FIELD SERVICE BULLETIN

FSB Number: LVCCFSB2003-130
Author: Tony Bryan/Rajesh Verma
Date: December 10th, 2003
Total No. of Pages: 4
Subject: **GSM Triplets – Antenna Issue**
Model Affected: V300, V500, V525
Level of Repair: 3

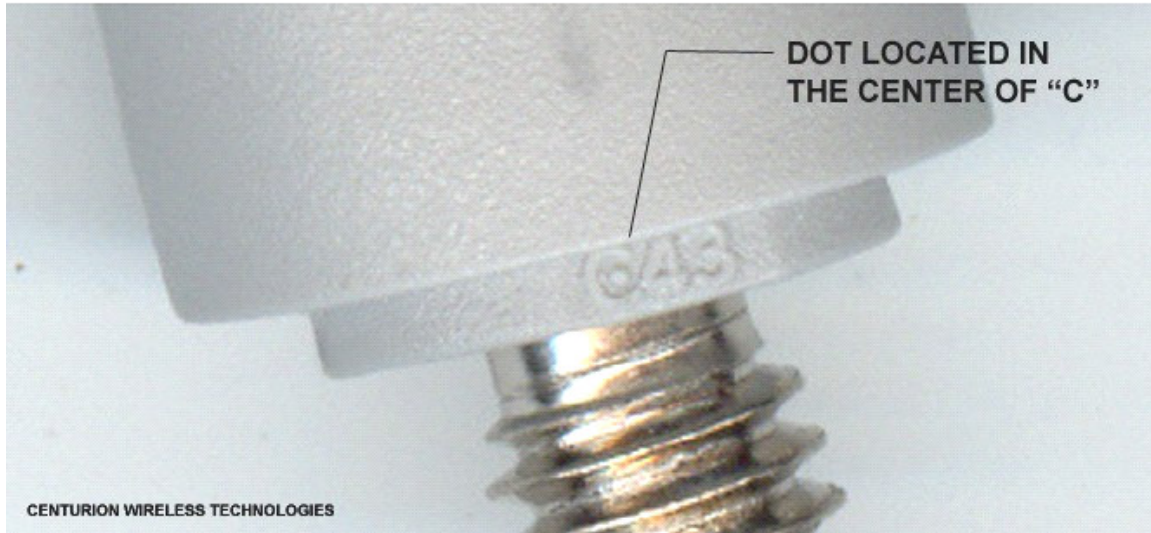
Automated fixtures have been implemented by Centurion to replace manual bending of the tang. A screening process, which includes a screening fixture to over-torque antenna, has been defined and implemented by the Quality team at Centurion in place to both fix production and identify means for sorting existing in house material.

Figure 1.0 – Identification of New and Screened Parts

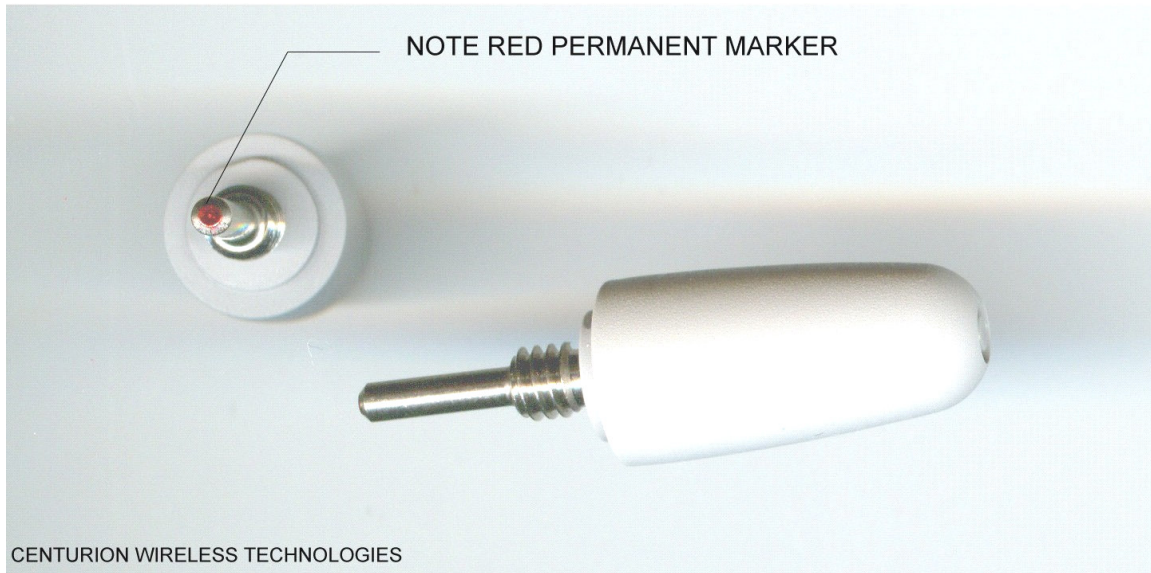
Centurion has replaced inventories with antennas processed after Nov.20th when all process improvements and screening was in place. New parts, built after Nov. 20th, are uniquely marked with a “Dot” inside the “C” at base of plastic. Screened parts will be marked with a “Red Dot” at the metal tip. See Figure 1.0 below.

**IDENTIFICATION METHOD FOR ALL V300 & V500
ANTENNAS MANUFACTURED STARTING NOVEMBER 20th.**

IDENTIFICATION METHOD FOR ALL SORTED V300 & V500 ANTENNAS

Please quarantine all existing stock of the 8588912N01 V300 and 8589122N01 V500/V525 antenna and replace with new parts built after November 20, 2003. See Figure 1.0 for identification markings on new parts.
